Re: ESCR CAG environmental questions from Wendy Brawer

Below please find responses to the questions that DDC and HNTB/Liro received in June on various environmental mitigation issues, as well as subsequent questions. The questions/statements from the CAG are in black, and the responses are in green. Please note that some of these concerns were addressed in the presentation that was shared at the June 2021 CAG meeting.

## #D FY 2021 Adopted Capital Commitment Plan

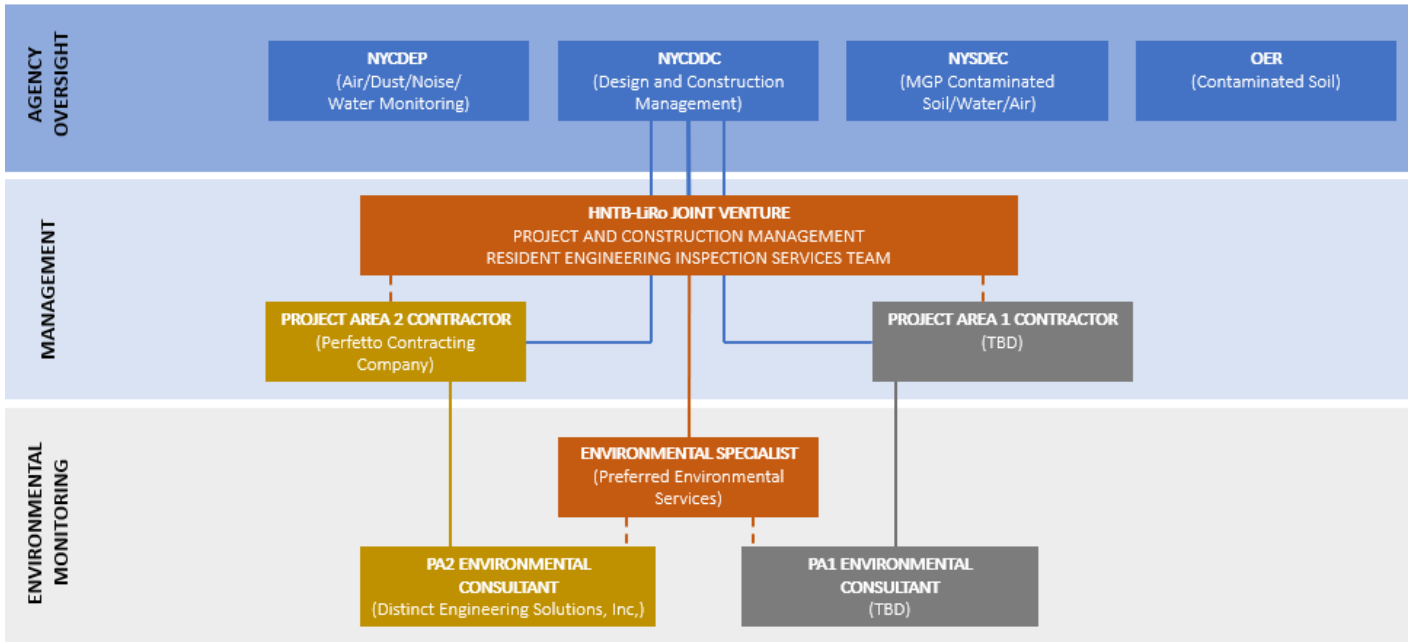
**In the 2021 Adopted Capital Commitment Plan, there's about \$53 M for the parallel conveyance (see #D below) is that the entire budget for all the ESCR related sewer work?**

There is additional sewer work in SANDRESM1 (Project Area 1) and SANDRESM2 (Project Areas 2); Parallel Conveyance (SANDRESM1) is not the entire budget for all ESCR related sewer work. For SANDRESM1, SANDRESM2, and SANDRESM3 there is a total of \$266 Million allocated for sewer related work. Regarding SANDRESM3, the City's adopted budget plan allocated \$75 Million for the project including sewer work.
